## APPENDIX D

### Consultation Record

Project Title	Pear Tree Solar Farm
---------------	----------------------

Meeting Title	Hydraulic Modelling Discussion
---------------	--------------------------------

*Figure 1: Locations on the River Hull which intersect the red line boundary for the site where breaches are not proposed.*

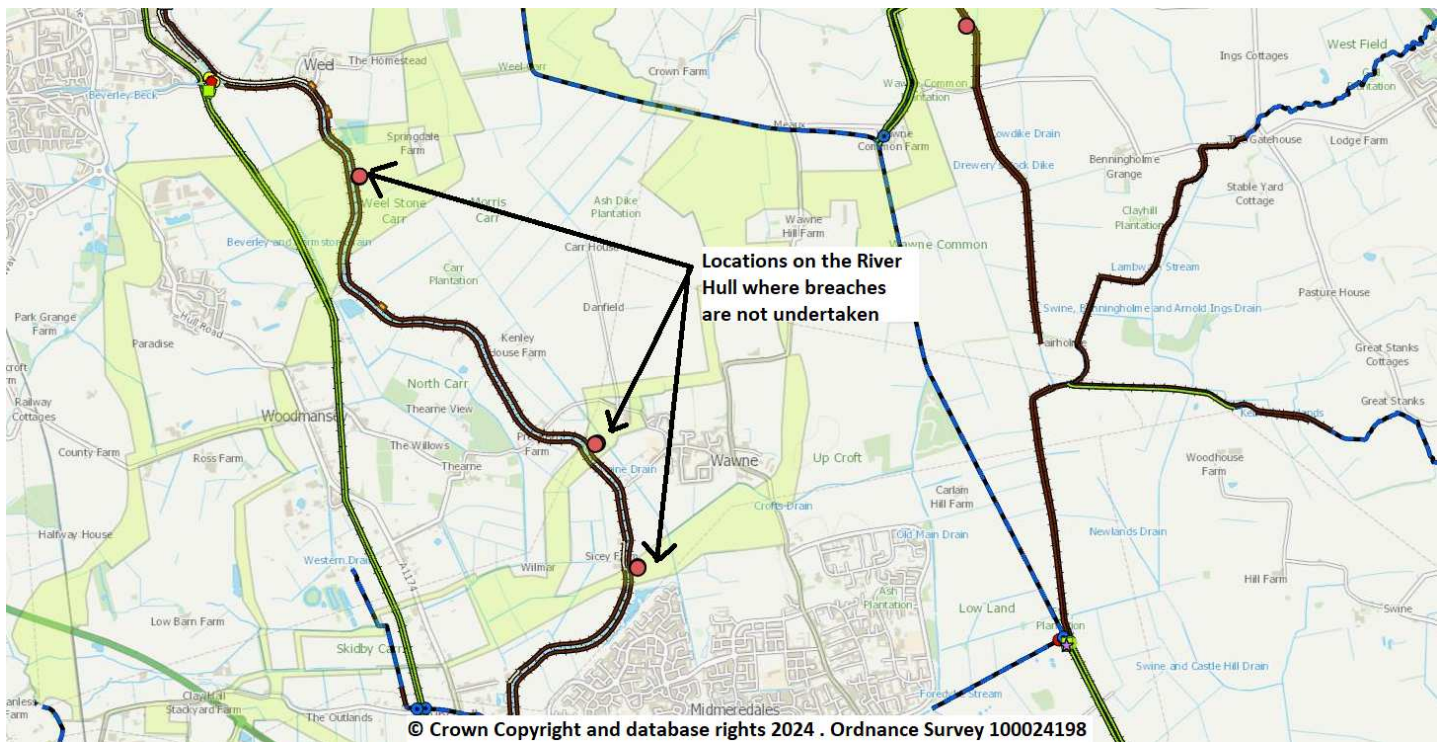
What was the rationale for not undertaking a breach at east 506700 north 438725, east 508280 north 436920, and east 508565 north 436090 on the left and right bank of the River Hull (figure 1 below)? Is this because these are relatively low risk areas for cable routing?
